# **Planning Commission**

### April 22nd, 2020 4:30 P.M.

APPLICATION FOR CONDITIONAL USE PERMIT FOR A DIGITAL MESSAGE BOARD SIGN FOR CEDAR POINT ON PARCEL 57-00771-000

### APPLICATION FOR SITE PLAN APPROVAL FOR PARKING AND DRIVE ALTERATIONS AT 1 CEDAR POINT DRIVE.

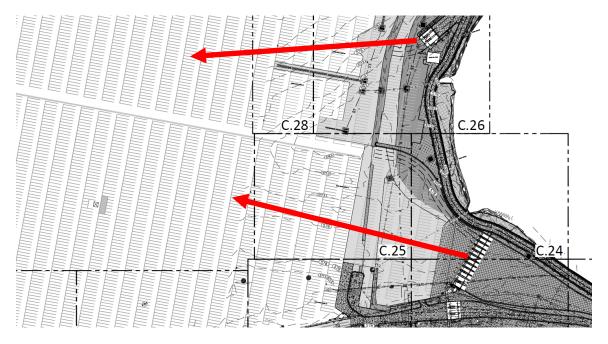
proposed site plan. Police believe that these changes should ease congestion on the busiest days of the year by allowing great intake capacity and reducing conflict points. In the image below you can see that the traffic will all be directed towards the park. Previously, traffic was permitted to head West towards Sandusky Bay then travel north along the Perimeter Road. Traffic will now need to go toward the front gate, then to the Perimeter Road. This should allow a constant flow from both Cedar Point Drive and Cedar Point Road.

\Users\kboehler\Desktop\275719\Engineering\CAD Drawings\C.43\_LANDSCAPING Sheet.dw

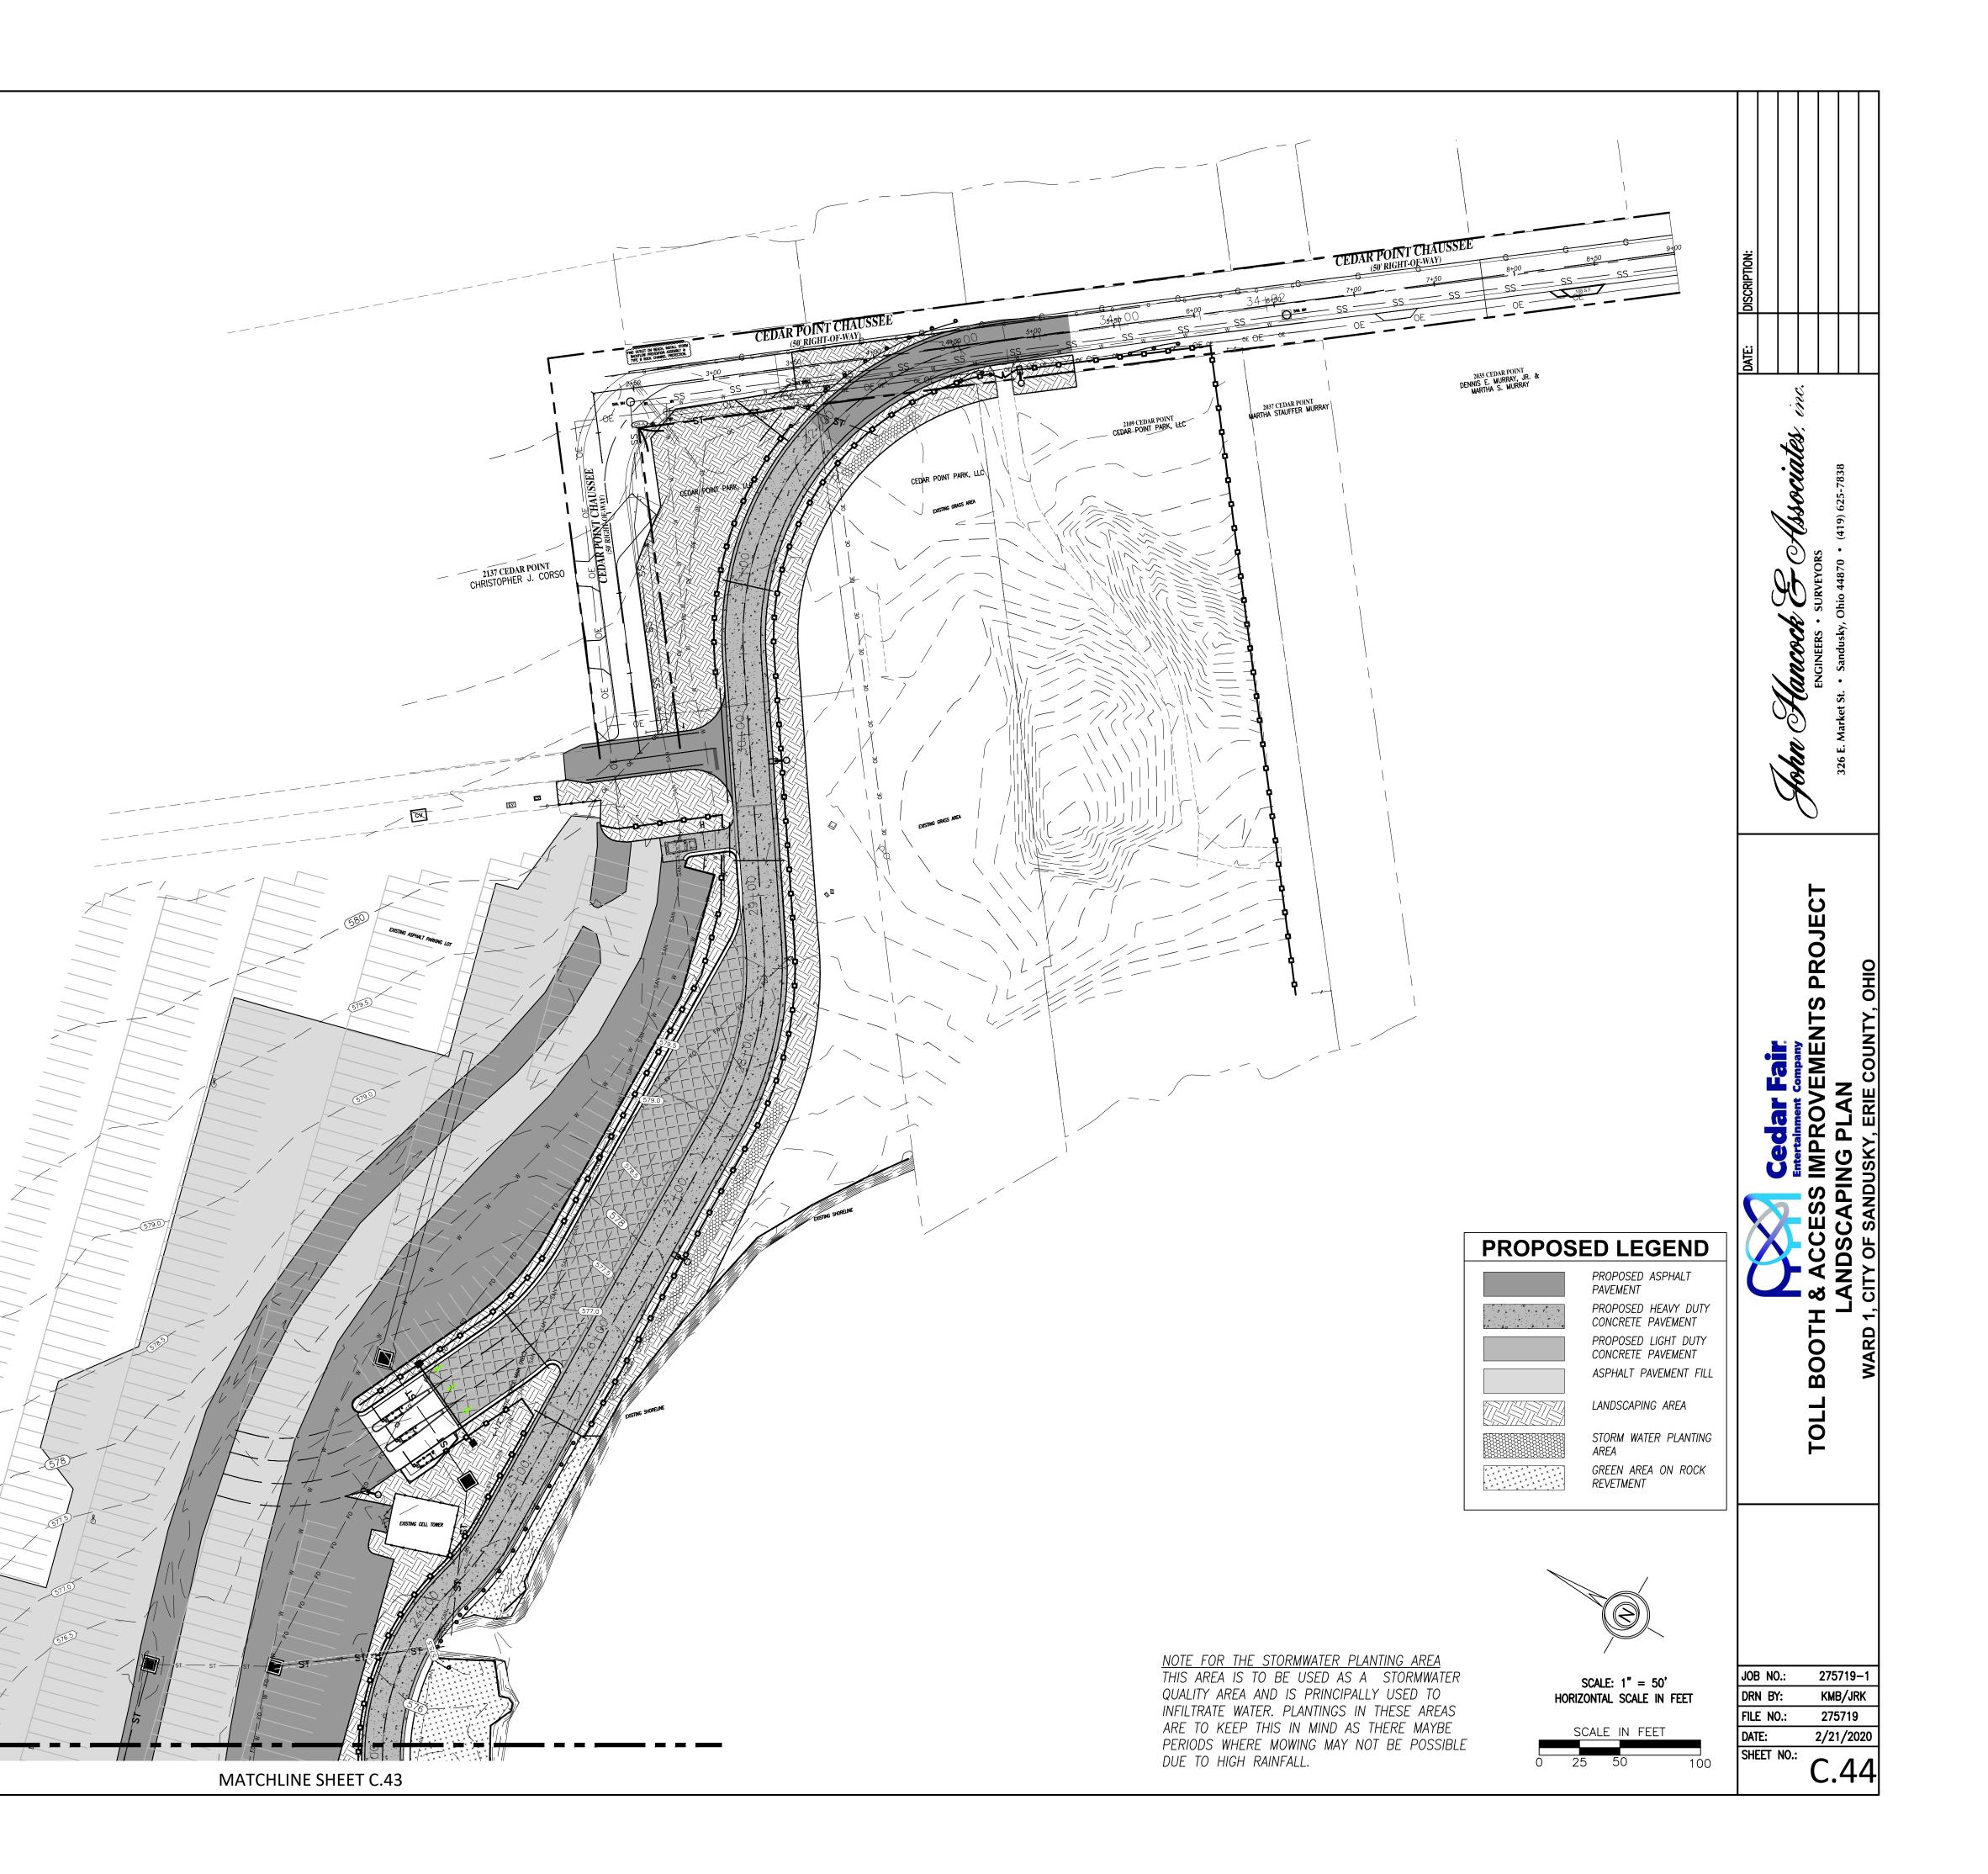
Planning Department Staff have requested more information regarding detailed cut sheets for proposed lighting. The lighting must not create glare on surrounding properties and are to be dark sky friendly. Staff has also requested details regarding the landscaping. While Staff has been provided with a general landscaping plan a more detailed landscaping plan is desired as well as clarification of whether or not all fencing will be post and beam or if they intend to install some privacy fencing. It is also important to note that there are no new landscape islands added into the parking area, but the applicant does show added landscaping between the new access way alignment and the new parking area. The applicant has said that this is meant to maximize the parking area.

- 1. The applicant provides, for staff approval, a revised landscaping plan that shows types and locations of plantings, as well as types, locations, specifications and examples of specific fencing to be installed.
- 2. The applicant provides, for staff approval, lighting cut sheets for staff approval of any proposed new lighting for the site.
- 3. The applicant creates a permanent easement or replats as necessary to designate the private road/drive. After recording, a copy of shall be submitted to staff for filing.
